SITING AND GRADING PLAN

Royal Pine Homes / Centerfield Properties Inc - 216102
"OAKRIDGE MEADOWS", RICHMOND HILL, ON

Block 51

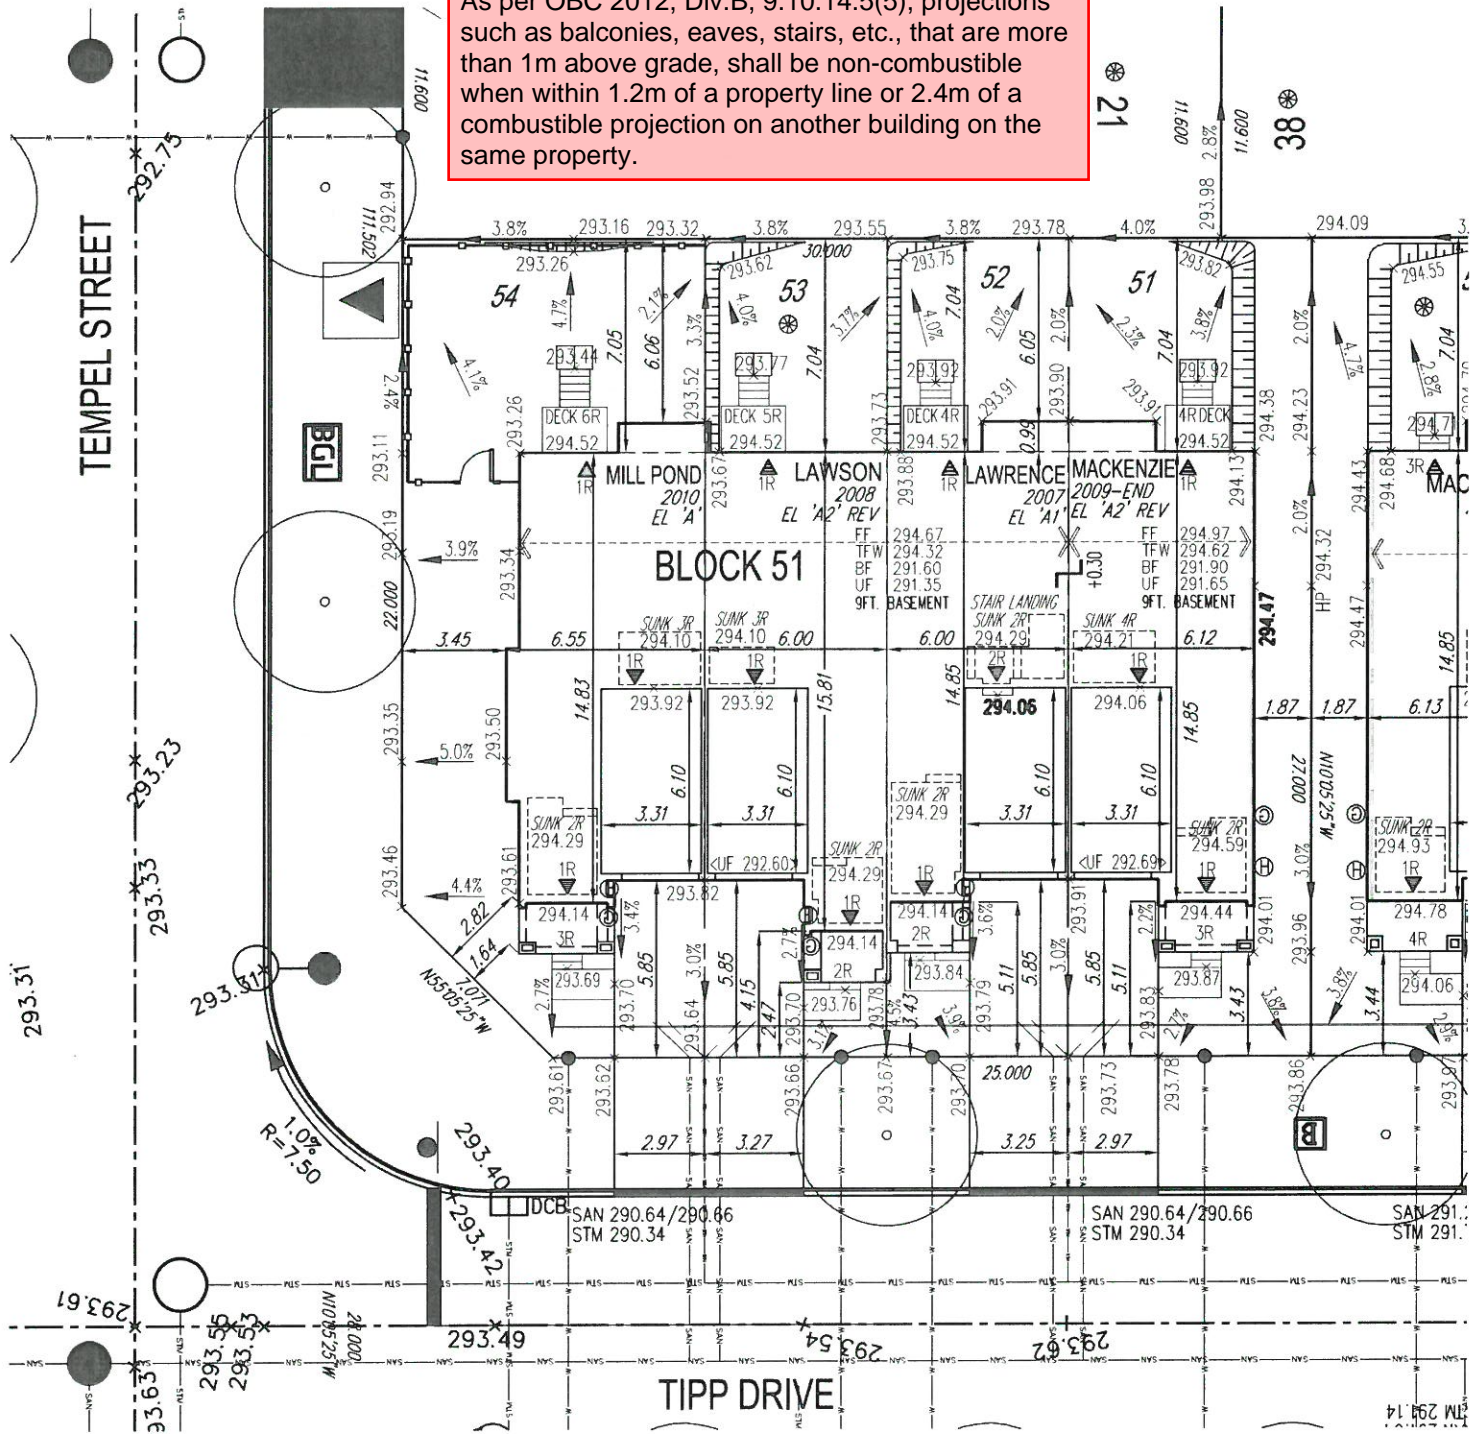
As per OBC 2012, Div.B, 9.10.14.5(5), projections such as balconies, eaves, stairs, etc., that are more than 1m above grade, shall be non-combustible when within 1.2m of a property line or 2.4m of a combustible projection on another building on the same property.

No unprotected openings permitted within 1.2 metres of the lot line as per 9.10.14 of the Ontario Building Code
